URBANE STUDIO

REF: 22-193

RE: Development Application No. DA.2023.0103

For land/premises at LOT 566 DP 1263952, 43 MCFARLANE AVENUE GOOGONG NSW 2620

Figure 1| Proposed Street trees to be removed.

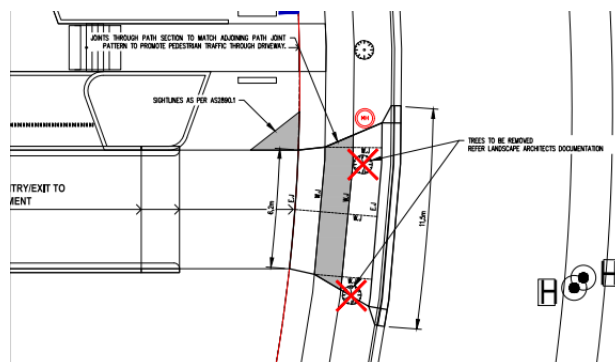
“Please provide details including photos of the trees to be removed and the location of compensatory tree planting.”

The current street trees have recently been planted, and consequently, they are relatively small in size. The picture on the next page, taken from McFarlane Avenue, illustrates two trees marked for removal, providing a perspective on their size and proportion. The reason for removing these trees is to make way for the construction of a driveway.

It's important to note that street trees are consistently spaced approximately 5.5-6 meters apart along all sides of the property, leaving no room for additional planting on the verge.

However, the proposed development aims to incorporate approximately 165 trees within private courtyards and the central open space. Given this substantial tree planting within the property and density of trees on the verge, the removal of the two smaller street trees will be offset by the considerable tree planting efforts within the development itself.

A headlight in the low-beam position

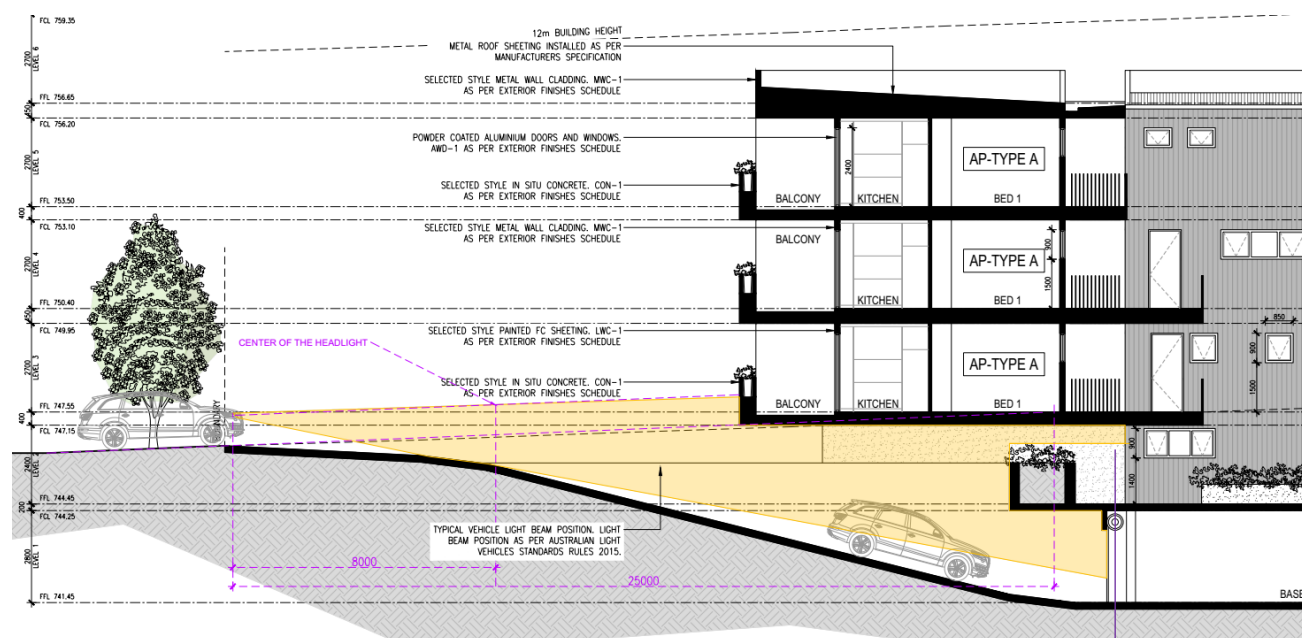
“The east facing units in Building 4 are likely to be impacted upon by vehicles entering and exiting the basement car park in respect of light and noise pollution. Please detail the mitigation measures proposed to ensure the relevant unit are not unacceptably impacted.”

Please see the section below, which has been produced for the basement ramp and units above, considering the light beams from a car entering the basement. This analysis is based on the Australian Light Vehicle Standards Rules 2015.

As illustrated in the section, the extended planter box placed on the edge of the ground floor will effectively block most of the light spill from cars entering the basement. Only a small portion of light, at approximately 2 meters above the ground, will bypass the planter box and hit a blank wall of unit 4.16 at ground level. It's important to note that unit 4.16 faces the laneway to the south and has no opening facing McFarlen Avenue, therefore the light impact will be zero.

For units located on top of the basement ramp, there would be no light pollution. It's worth noting that these balconies open into the kitchen and living room areas of these units, and there would be no detrimental impact of noise pollution for the bedrooms of these units as they are located at the rear. Should Council feel necessary, use of double glazing for these balconies can form part of conditions of consent.

The light may penetrate over the planter box but will hit a blank wall of unit 4.16 at ground level.
